SERVICE BULLETIN REVISION NOTICE

ENGINE — VALVE RING ASSEMBLY — REPLACEMENT OF THE VALVE RING ASSEMBLY AND
ASSOCIATED HARDWARE TO IMPROVE DURABILITY

Turbojet Engine Service Bulletin No. V2500-ENG-72-0704 Revision No. 1 dated November 18, 2019.

ENGINE — VALVE RING ASSEMBLY — REPLACEMENT OF THE VALVE RING ASSEMBLY
AND ASSOCIATED HARDWARE TO IMPROVE DURABILITY

LOCATION OF VALVE RING ASSEMBLY, PINS AND BUSHES
72-32-70
FIGURE 1

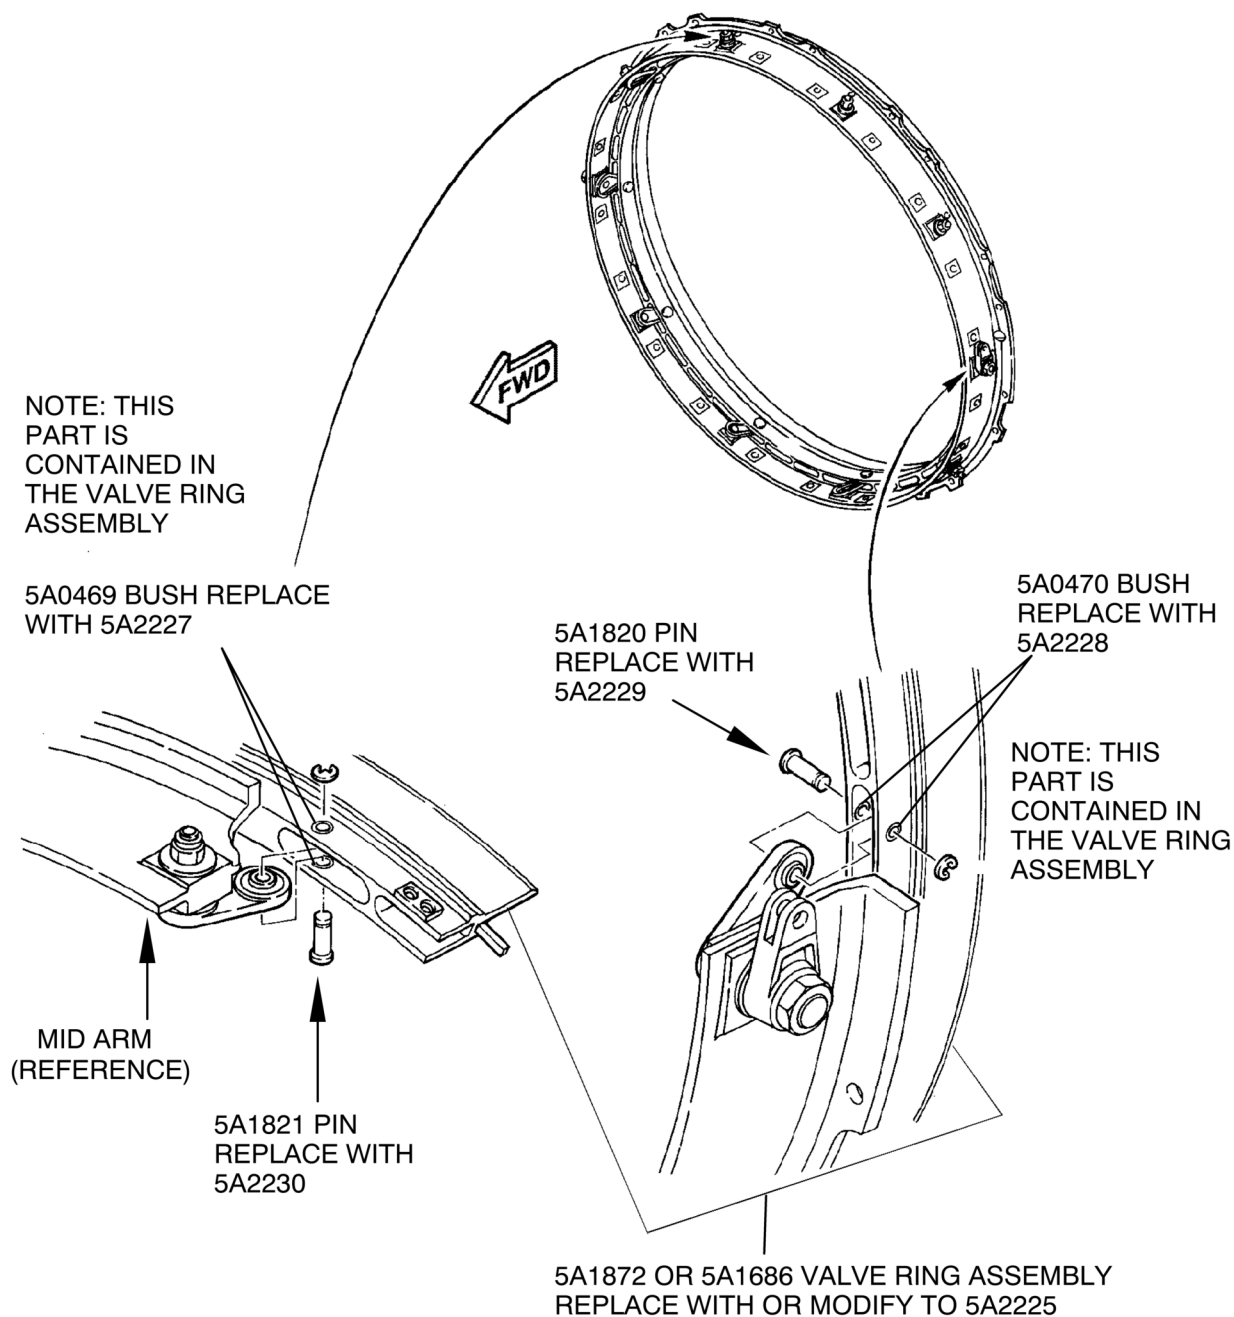
1. Replace the valve ring assembly as follows or continue to Step 2 for modification instructions. See Figure 1.
 - A. Replace the Valve Ring Assembly, PN 5A1872 or PN 5A1686 with PN 5A2225, as specified in Reference 4 or 5, Engine Manual, Chapter/Section 72-32-70, Disassembly-001 and Assembly-001. See Figure 1.

- (1) Replace the Pins, PN 5A1820 and PN 5A1821 with Pins, PN 5A2229 and PN 5A2230. as specified in Reference 4 or 5, Engine Manual, Chapter/Section 72-32-70, Disassembly-001 and Assembly-001. See Figure 1.

LOCATION OF BUSHES
72-32-72
FIGURE 2

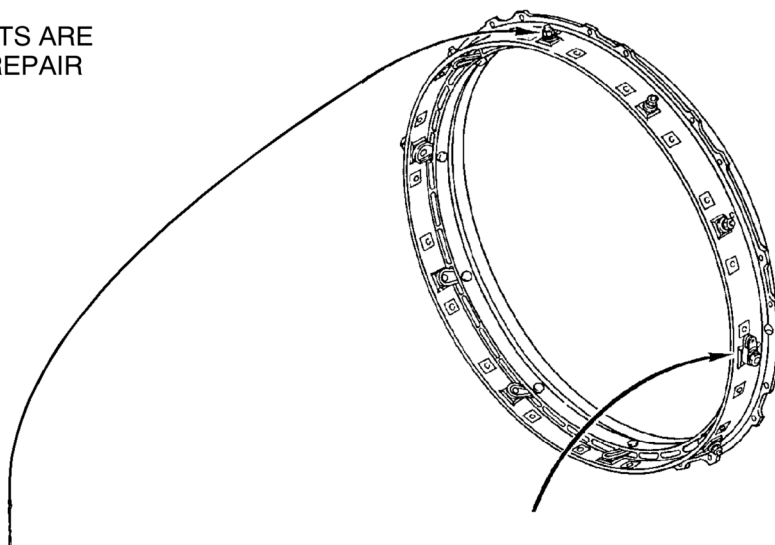
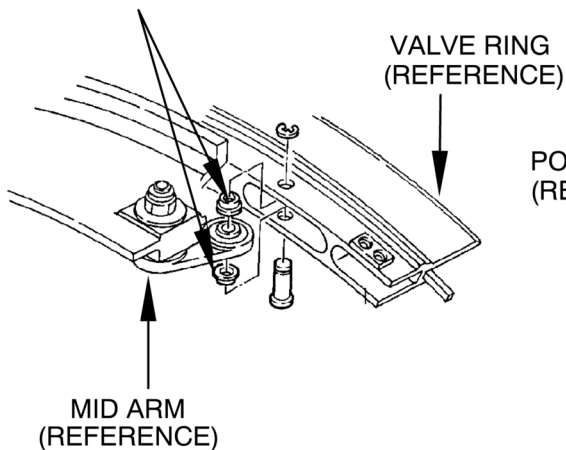
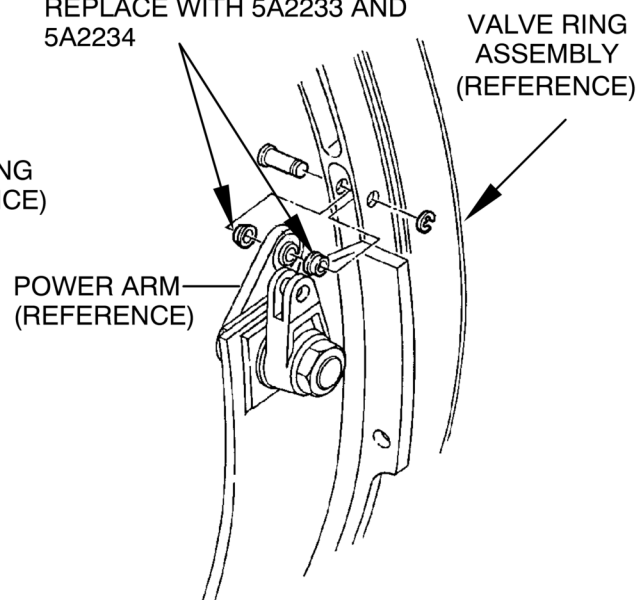
- (1) Install the new Bushes, PN 5A2227, PN 5A2228, PN 5A2231, PN 5A2232, PN 5A2233, or PN 5A2234 to the bush holes of the corresponding size. See Figure 2.

5A1952 AND 5A1953 BUSH
REPLACE WITH 5A2231 AND
5A2232

5A1843 AND 5A1844 BUSH
REPLACE WITH 5A2233 AND
5A2234

SCALLOPING REWORK
FIGURE 3

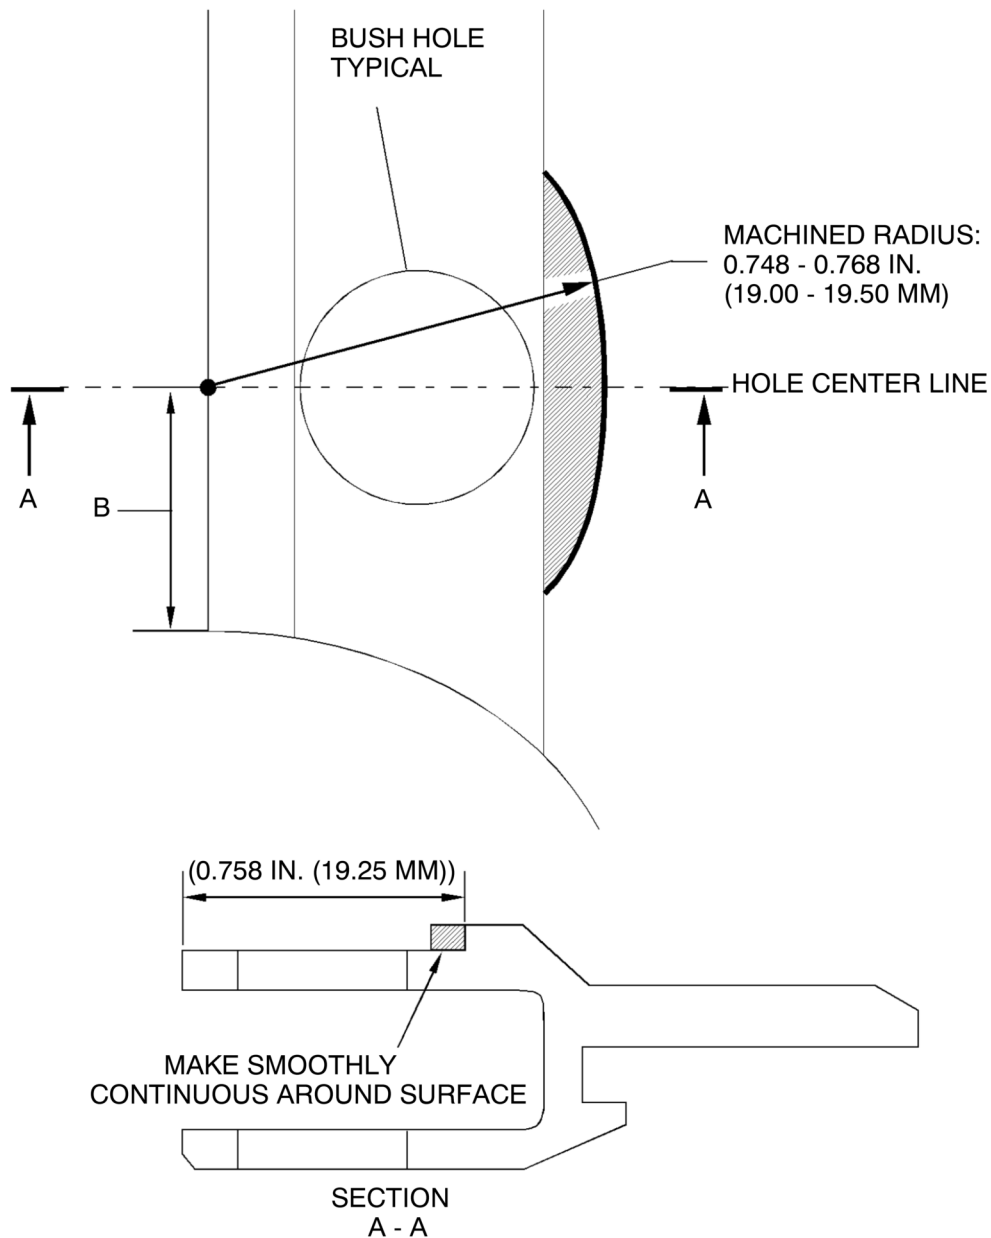
- C. Machine a scallop to the surfaces near all the bush holes. See Figure 3.
 - (1) If there was the scallop blended area, as specified in Reference 4 or 5, Engine Manual, Chapter/Section 72-32-72, VRS1750, machine the surface over the repaired area. See Figure 3.

NOTE: The machined area in Figure 3 is to be larger than the repaired area as specified in Reference 4 or 5, Engine Manual, Chapter/Section 72-32-72, VRS1750.

- (b) Use a 10X magnifying glass.
 - (2) Dimensionally inspect the scalloped areas.
 - (a) Make sure the scalloped areas satisfy the requirements in Figure 3.

LOCATION	B
	+0.04/-0.04 IN. (+1.0/-1.0 MM)
HOLE NO. 1 & 6	0.39 IN. (10 MM)
8 POSITIONS EXCEPT HOLE NO. 1 & 6	0.16 IN. (4 MM)

VALVE RING ASSEMBLY
CHART A

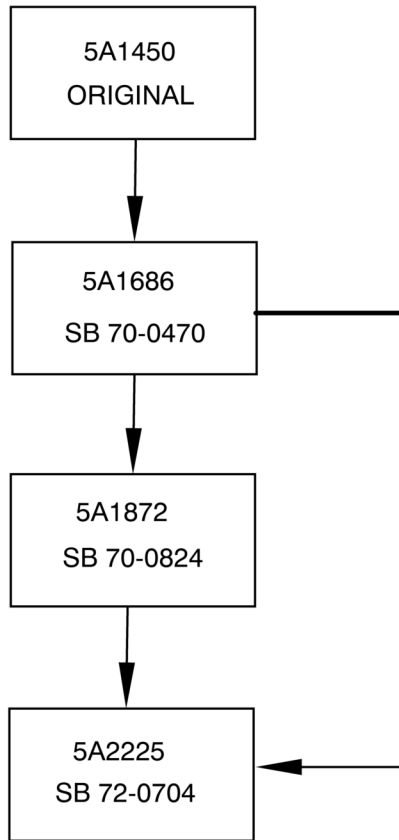
To update Figure 1 and Chart A to show progression from the Valve Ring Assembly, PN 5A1686 to PN 5A2225.
